RHODE ISLAND DEPARTMENT OF TRANSPORTATION

Rt 5 - Lambert Lind Hwy C-1 (Mayfield Ave - I-95)

NOTICE TO PROSPECTIVE BIDDERS

ADDENDUM NO. 1 Prospective bidders and all concerned are hereby notified of the following changes in the Plans, Specifications, Proposal and Distribution of Quantities for this contract. These changes shall be incorporated in the Plans, Specifications, Proposal and Distribution of Quantities, and shall become an integral part of the Contract Documents.

CHECKED BY CJ DATE 2/18/2020 SCALE AS SHOWN

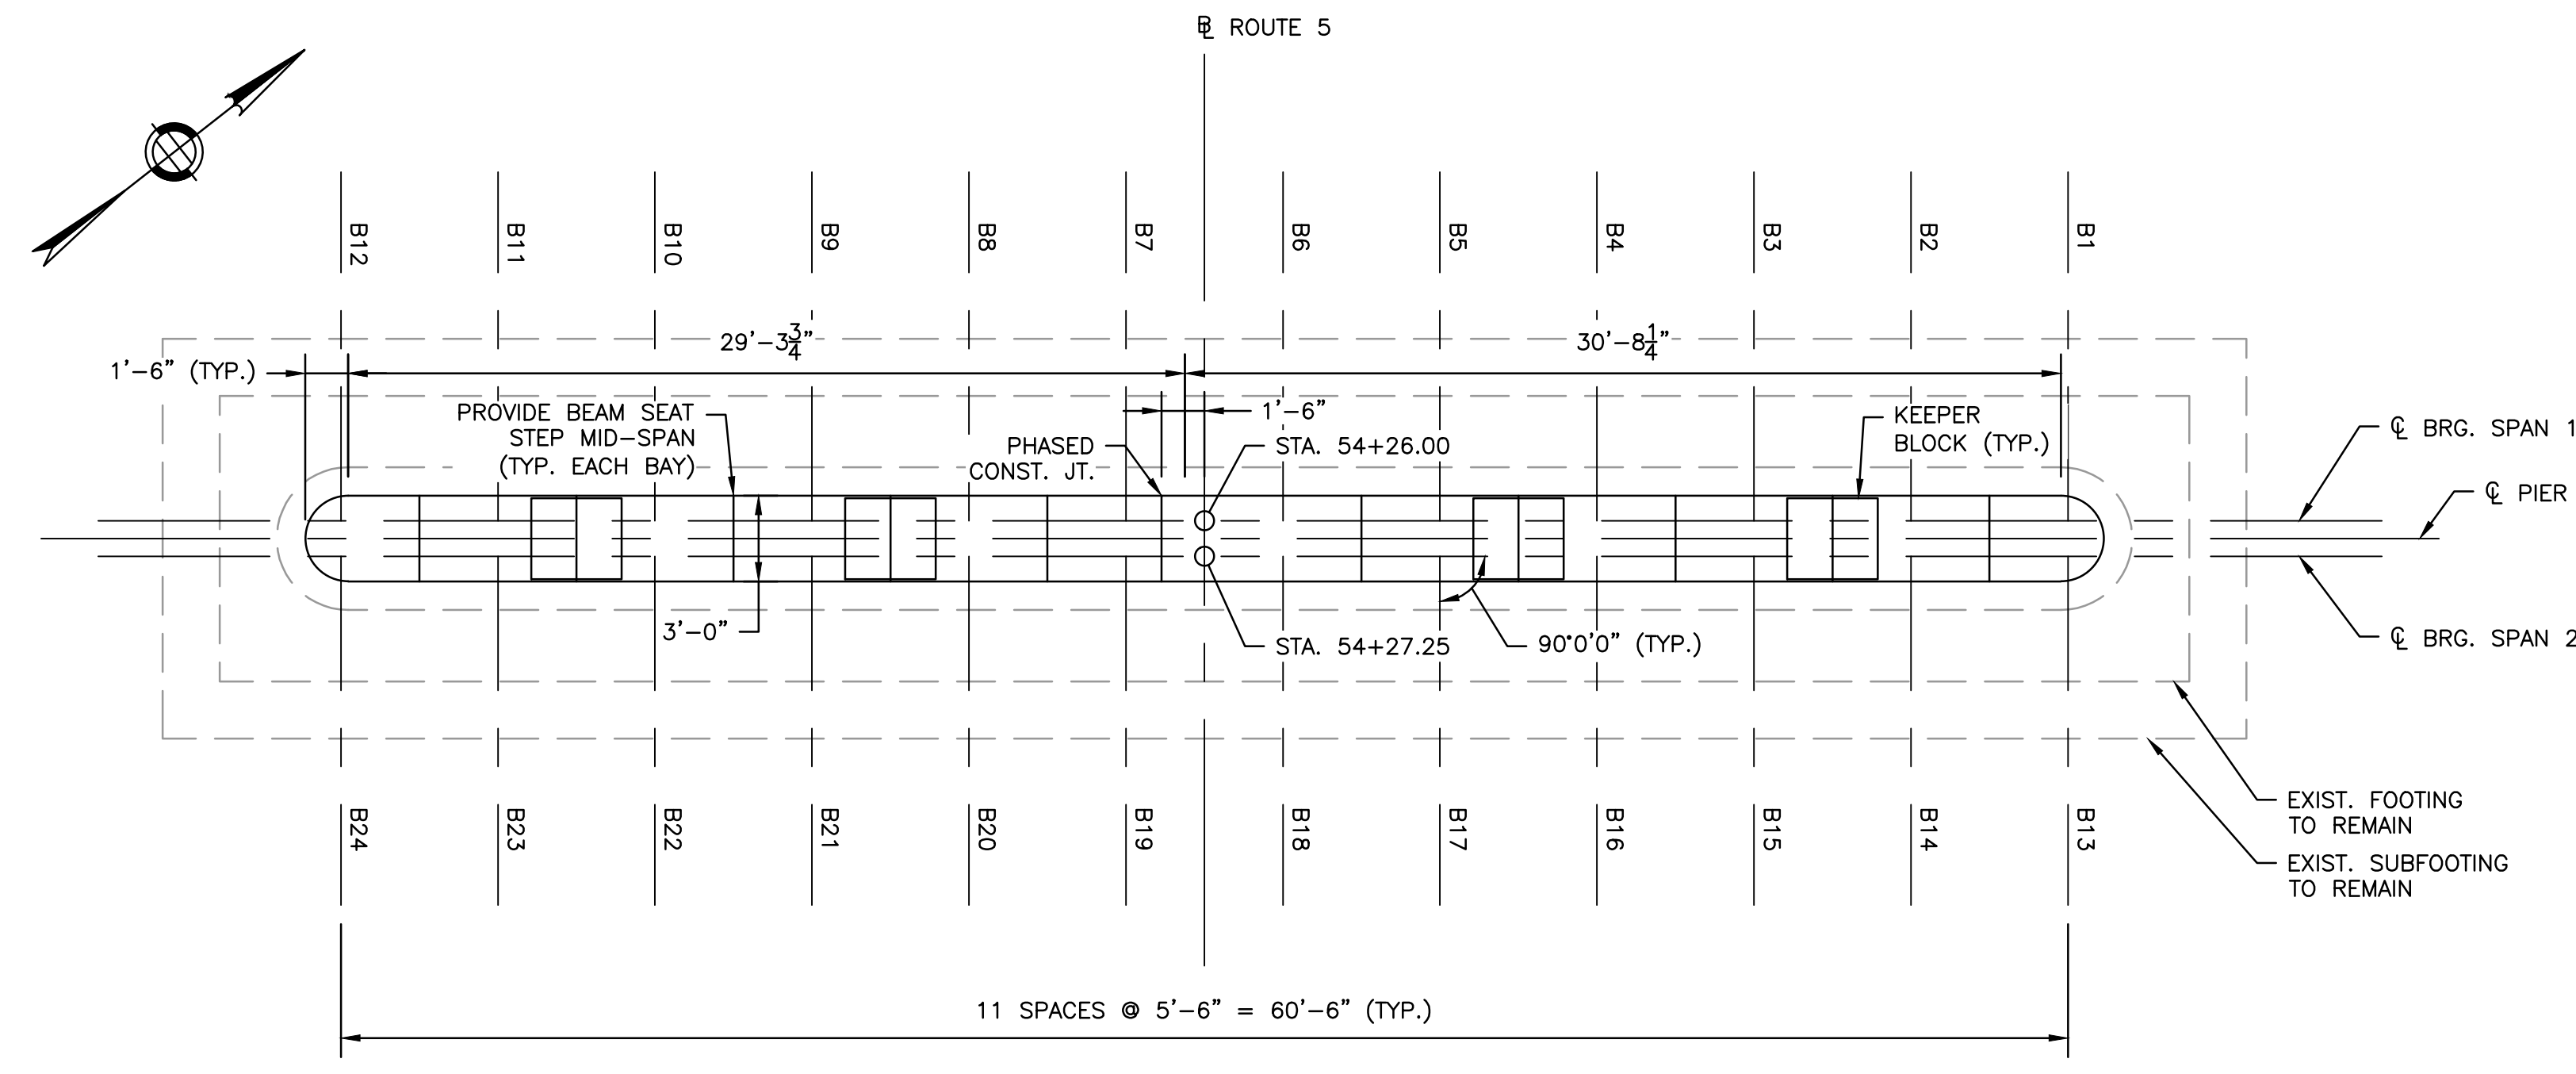
In Volume 2, the 'Mud Line' elevations shown on Sheet 10 of 36 appear very different from the elevations noted on Sheet 17 of 36. Please clarify which bottom elevation represents the actual field conditions.

In Volume 2, the 'Mud Line' elevations shown on Sheet 10 of 36 appear very different from the elevations noted on Sheet 18 of 36. Please clarify which bottom elevation represents the actual field conditions.

Approximate mud line elevations on Sheet 10 and 18 have been edited per the 2017 RIDOT Underwater Inspection Report and will be included as part of Addendum 1.

Approximate mud line elevations on Sheet 10 have been edited to match Sheet 17. Sheet 10 Rev1 will be included in Addendum 1.
